File number: AP-AG-11-0051

**MODIFICATION ACCEPTANCE LETTER (MAL)
FOR
Approved Meters and Devices**

Positive Displacement Rotary meter

G-0102, G-0156, G-0203, AG-0316, AG-0358, AG-0549

WARNING & ARROW PLATE
ROMET P/N 1-441-17

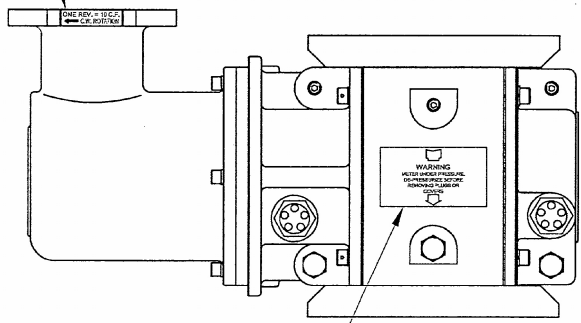
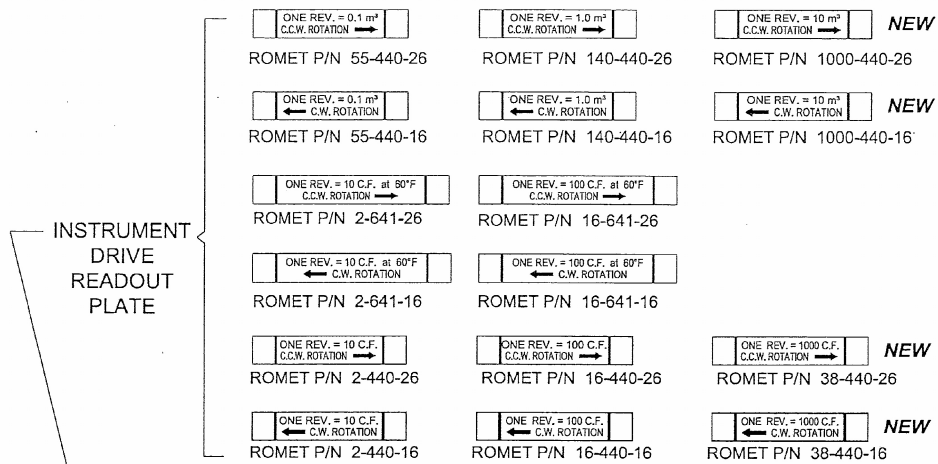
The purpose of this Modification Acceptance Letter is to acknowledge changes to the nameplate material for the nameplates which indicate flow direction, cubic feet per revolution and direction of rotation. Refer to attached photos. The old nameplates were metal. The new nameplates are manufactured from a polyester film called Mylar® and can be affixed to the meters approved under the above noted Notices of Approval.

17 aluminum plates to be changed to Mylar (polyester) film with pressure sensitive adhesive backing, weatherability and UV resistance.
